# Shoebury Common Alternative Proposal

Technical Review

September 2013

Black & Veatch Ltd (B&V) has been contracted by Southend-on-Sea Borough Council (SBC) to review and cost the alternative option for the Shoebury Common frontage as proposed by APS Design Associates Ltd. This report details the B&V finding and summarises the estimated costs of the proposals.

PROPOSED SITE SECTION 2

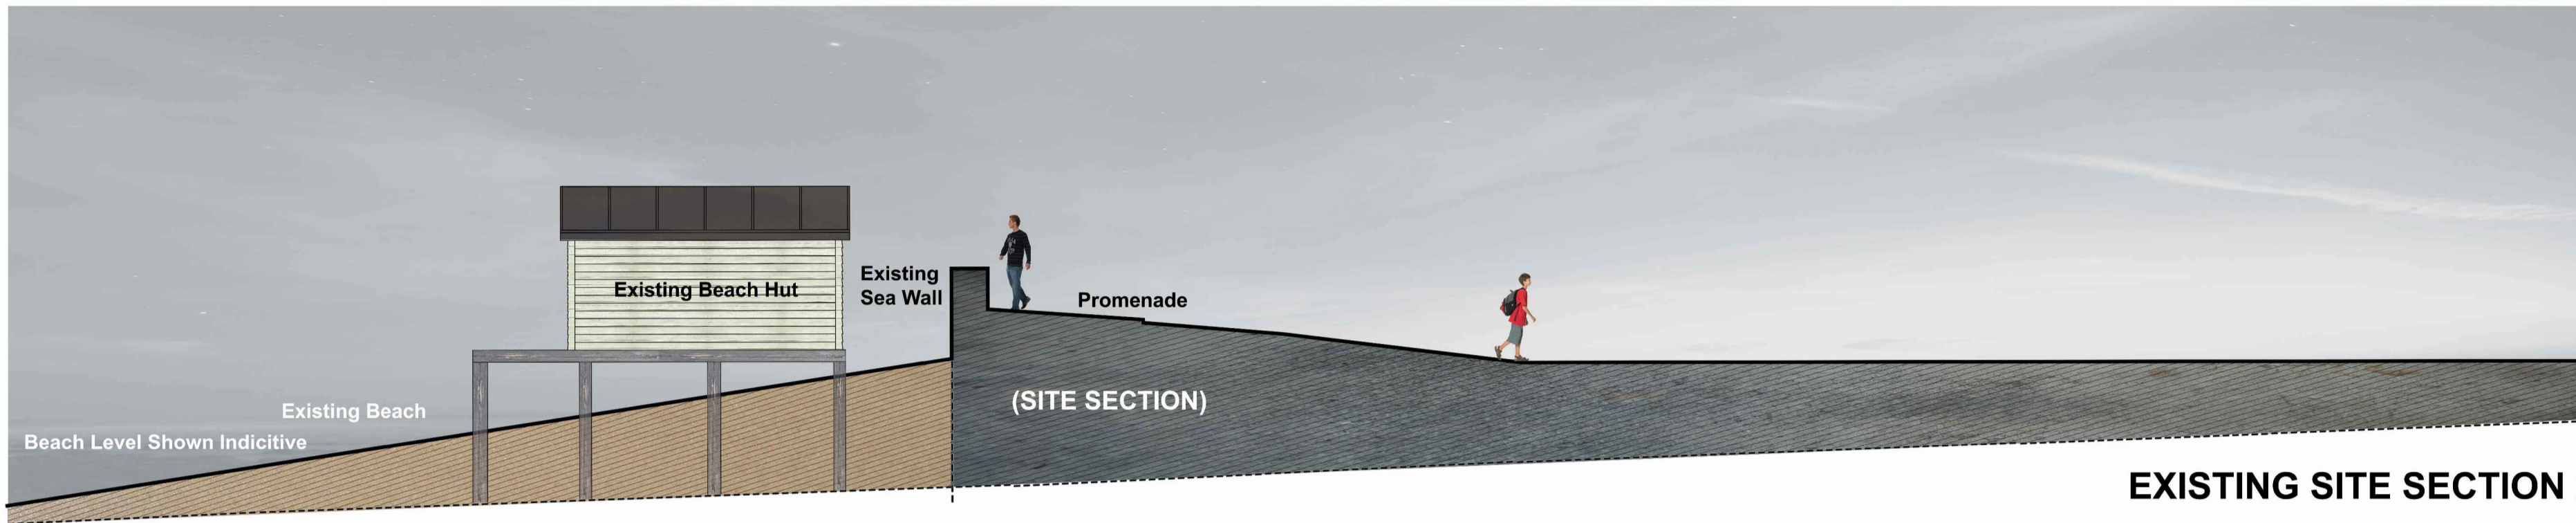
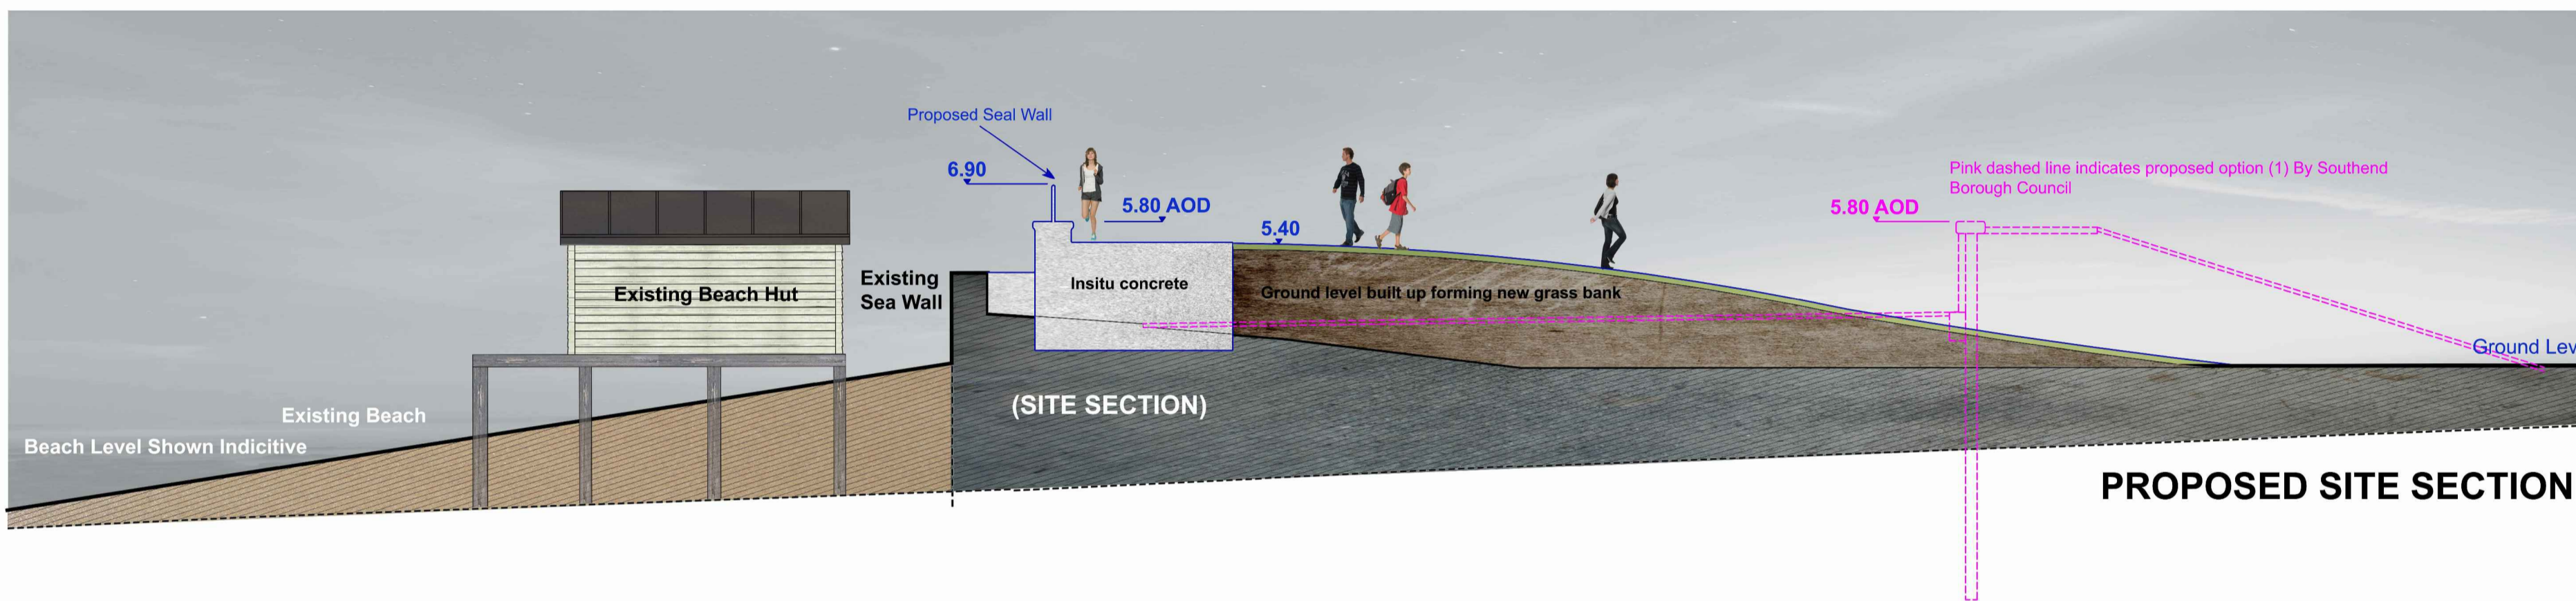
Section 2 involves using in-situ concrete to raise the existing seawall and promenade behind to a new level of 5.80mAOD, and raising the ground level behind by landscaping the slope with new imported material with a grass seeded surface.

Following a comparison of the proposals against the 2011 topographic survey it is clear that the levels shown within the alternative proposal are only indicative and are not drawn to a true scale.

It should also be noted that the beach levels shown on the proposals, which in some sections are shown to be approximately 4mAOD is fairly misleading as the topographic survey shows the crest of the beach to be as low as 2-3mAOD.

The proposals do not include any details of drainage, and it is not clear from the sections how the drainage of pluvial runoff will be incorporated into the scheme. It is also evident that existing surface water drainage from both the road and adjacent land behind the existing defences will be affected by the proposed scheme.

PROPOSED SITE SECTION 3

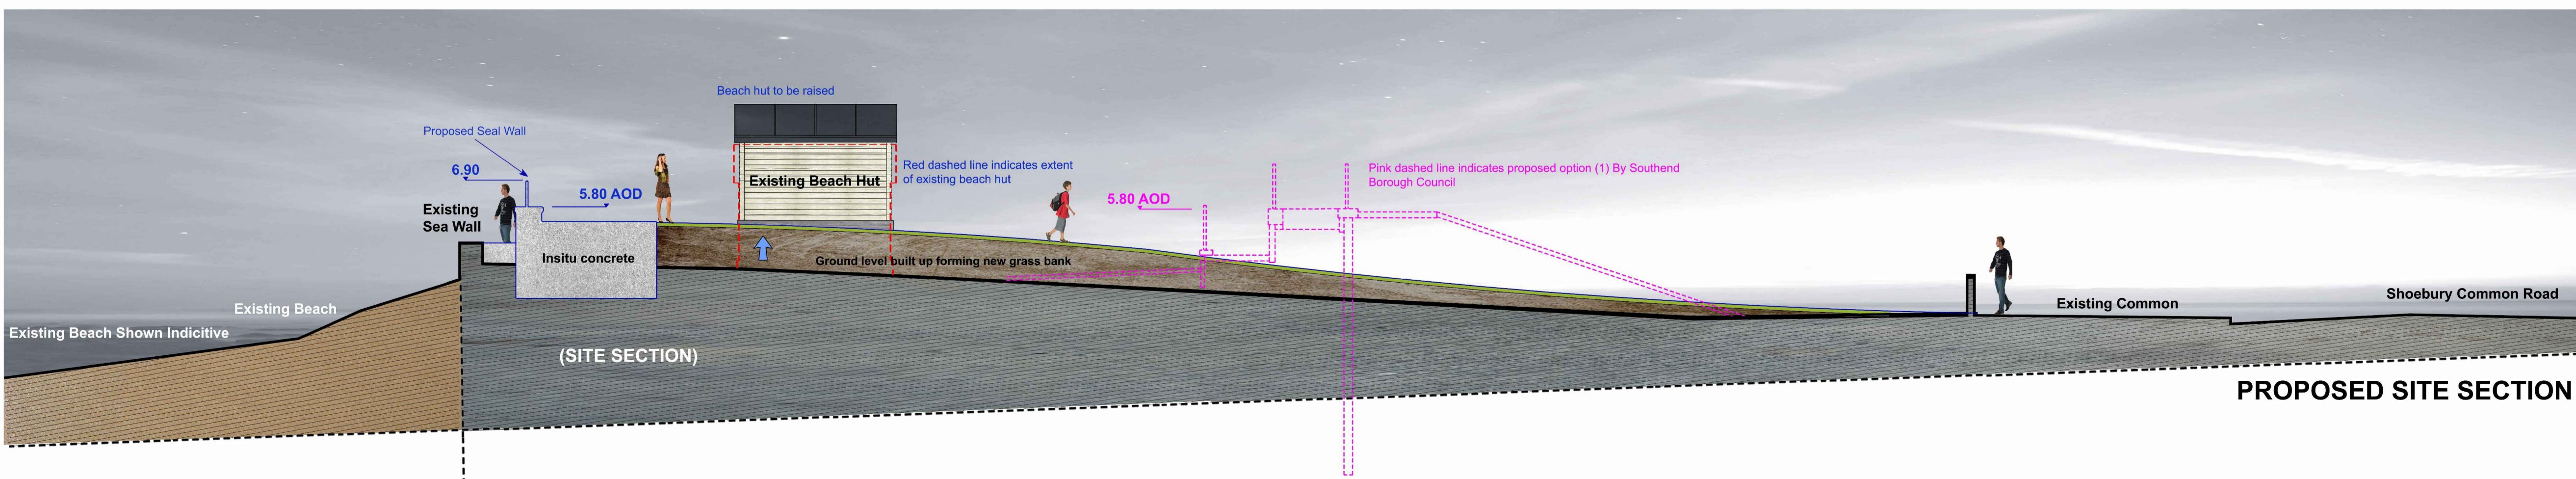
Both Sections 3 and 4 involves using in-situ concrete to raise both the existing seawall and promenade to a new level of 5.80mAOD, and raising the ground level behind by landscaping the slope with new imported material with a grass seeded surface. This section also involves the raising of the existing beach huts that are currently situated on the existing promenade by approximately 1-2m.

The proposals involve the removal, temporary storage, and reinstatement of approximately 169 no. beach huts. However, an initial inspection of the beach huts has identified that they are of variable construction type, age, and condition. It is therefore considered quite likely that a significant proportion of them will be damaged beyond repair following their removal.

In addition, the raising of the beach huts by over a metre would result in an additional detrimental impact on the landscape and sea views from Shoebury Common Road, and both the properties of Lodwick and Letrim Avenue.

It appears from the proposals that following the completion of the works the promenade will be reduced in width by approximately 1-1.5m and an additional 0.5-0.75m will become grassed. It is believed that this may present a problem for both service and emergency vehicles that will require continued access along the promenade. In addition, this would limit the amount of amenity space available to each of the beach hut owners in front of their huts.

**COUNTY BOROUGH OF SOUTHEND-ON-SEA**  
**SHOEBURY COMMON SEA WALL.**

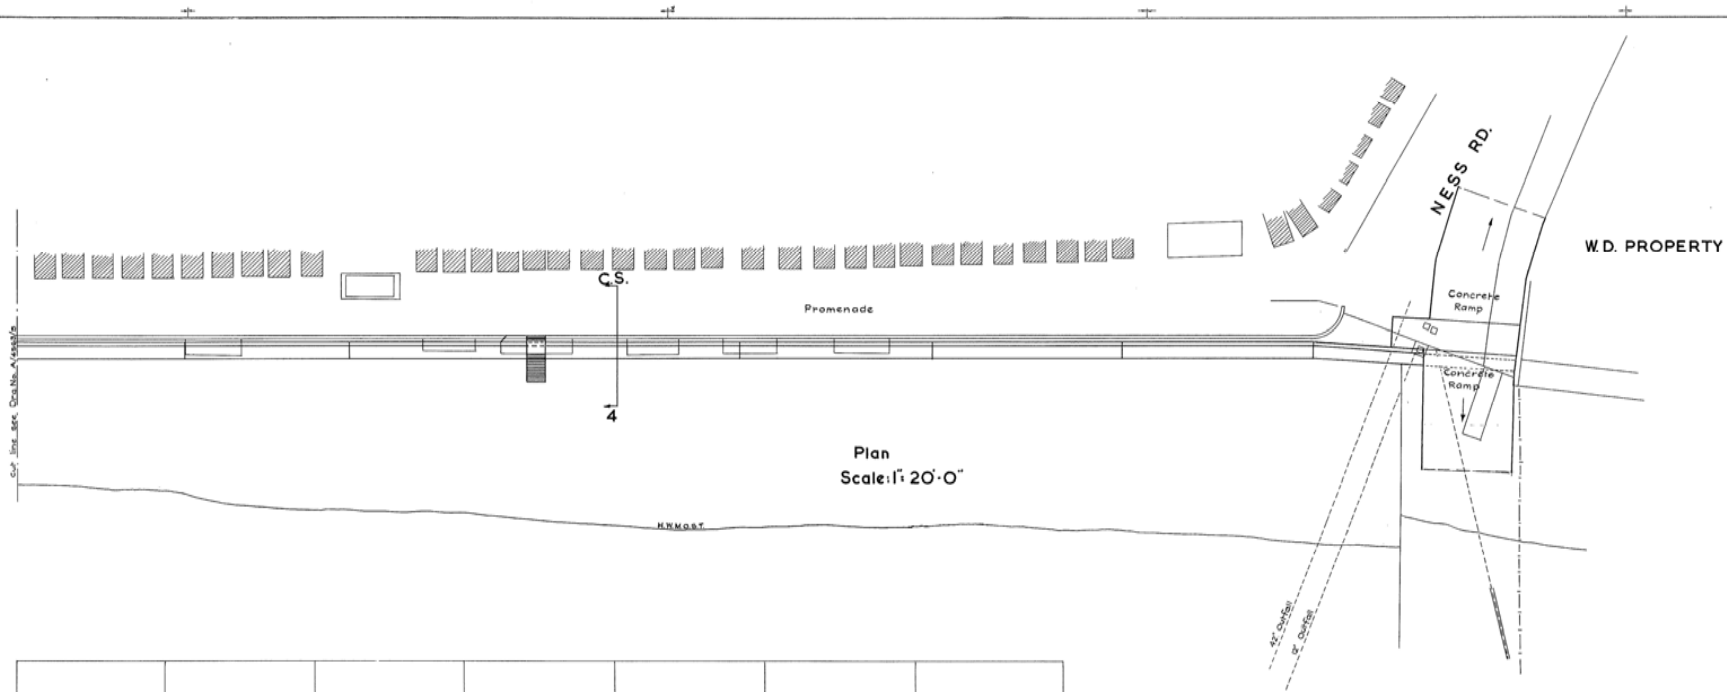
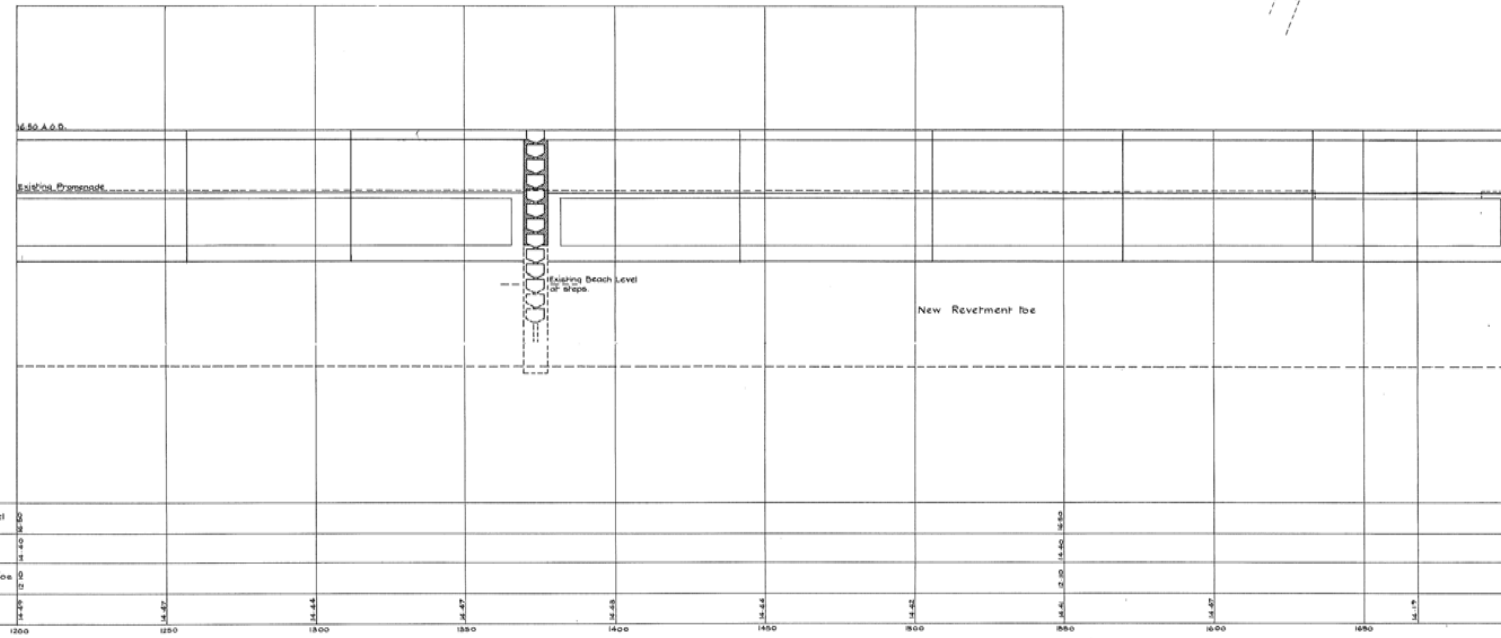
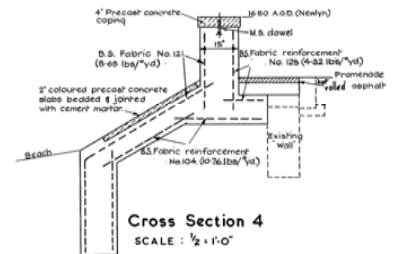
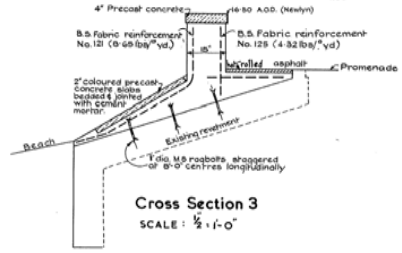
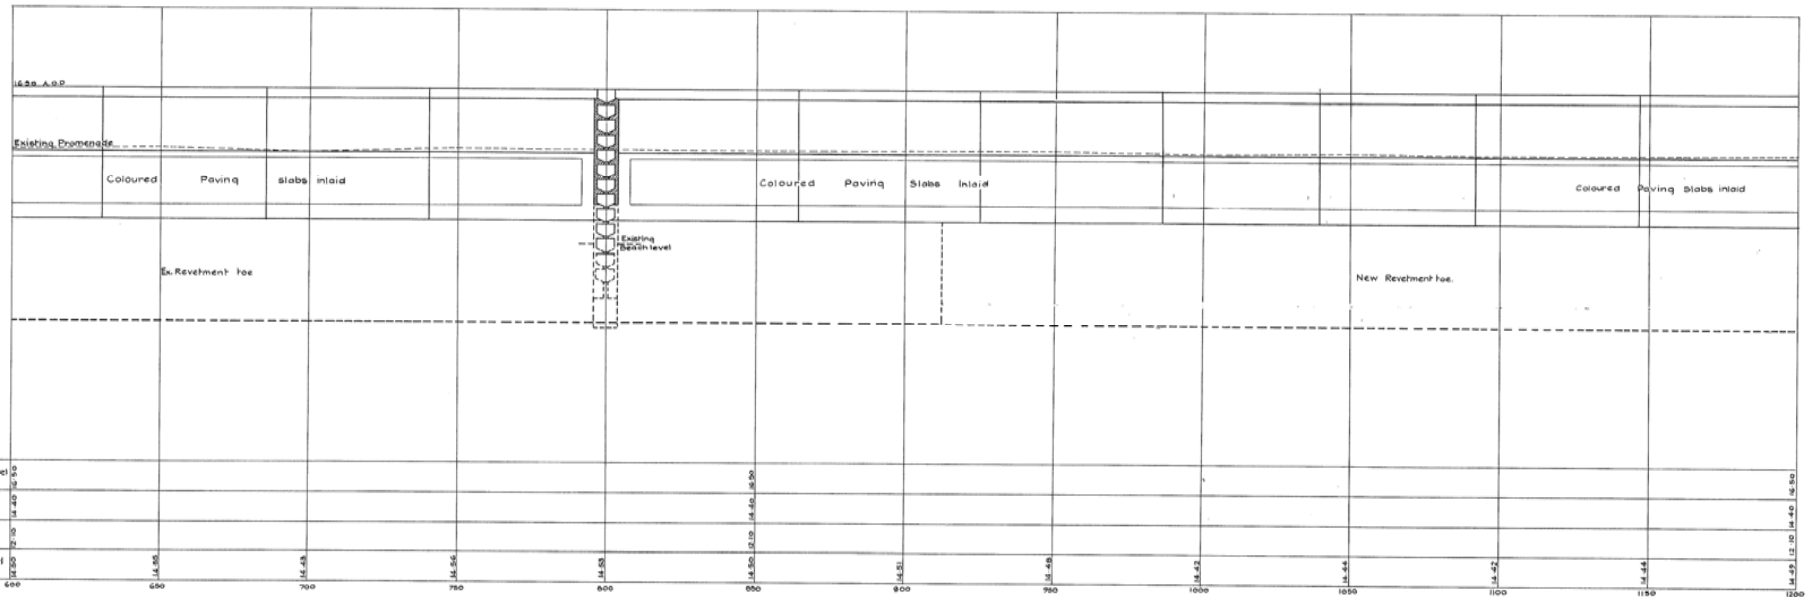
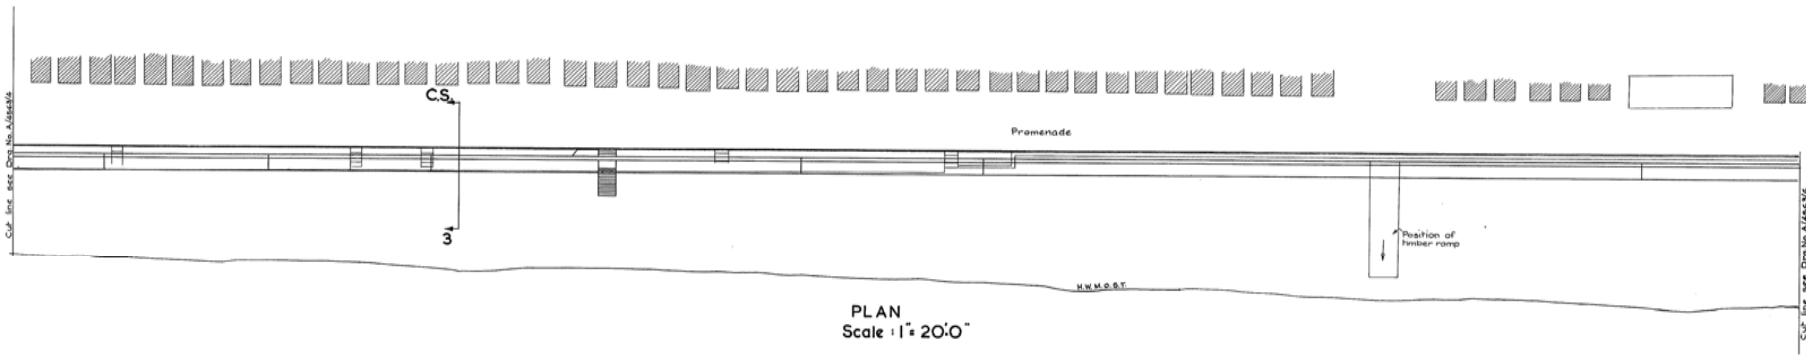
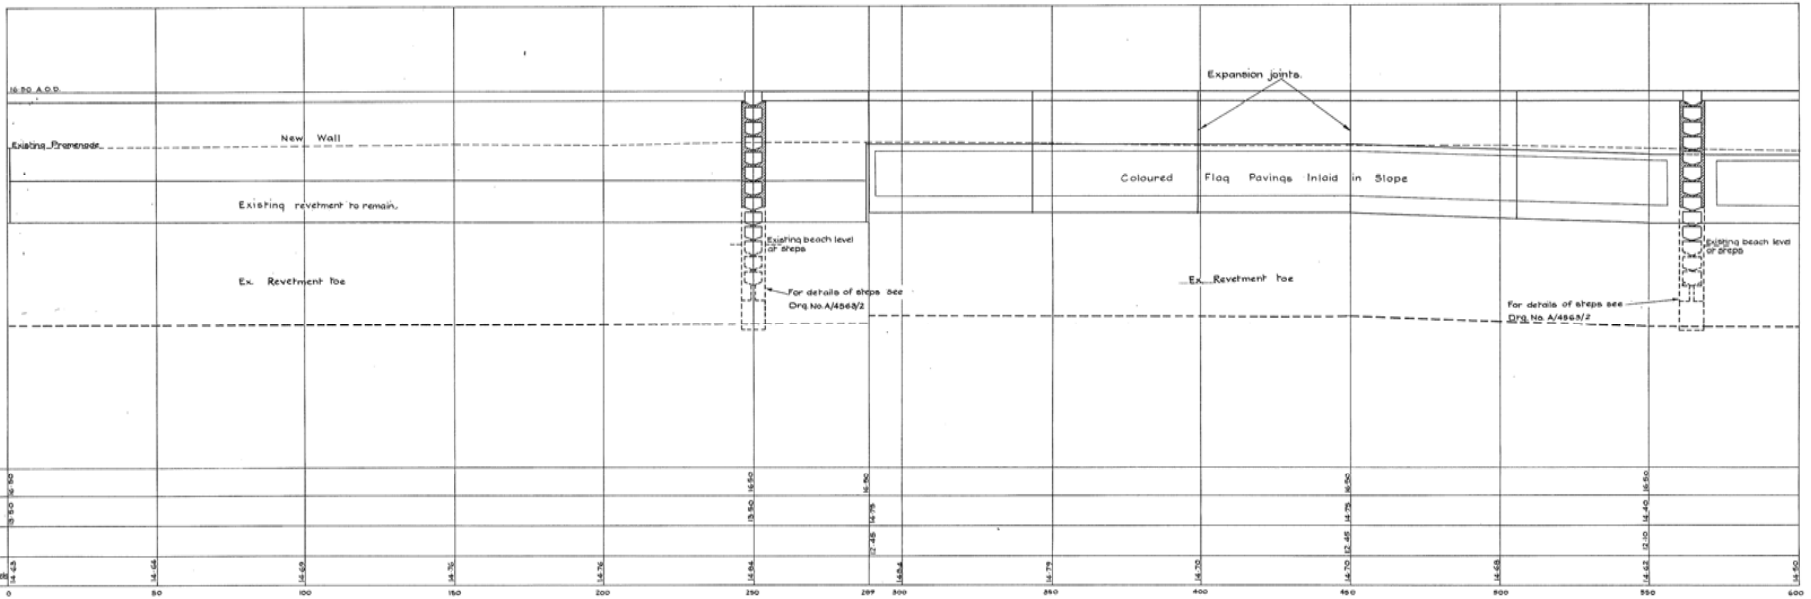
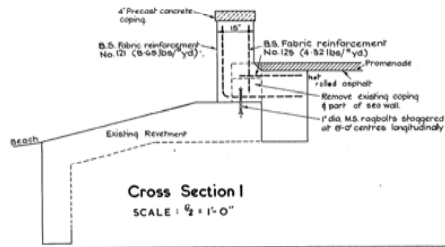
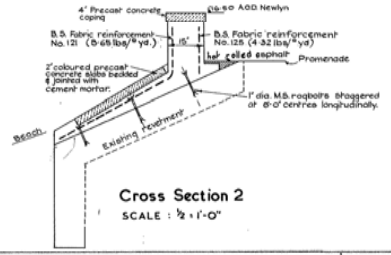
Further investigation into the existing frontage by SBC has uncovered some 'As-Built' drawings for the existing seawall (Appendix B). This has revealed that the existing Seawall does not have very substantial foundations, with only a limited amount of reinforcement in the face of the concrete (probably only designed to prevent surface cracking).

Consequently, it is estimated that in places (particularly in the east) the existing seawall will not be able to withstand the loading required to support either the raising of the seawall and promenade or the construction traffic required to undertake the works and would be expected to fail through sliding.
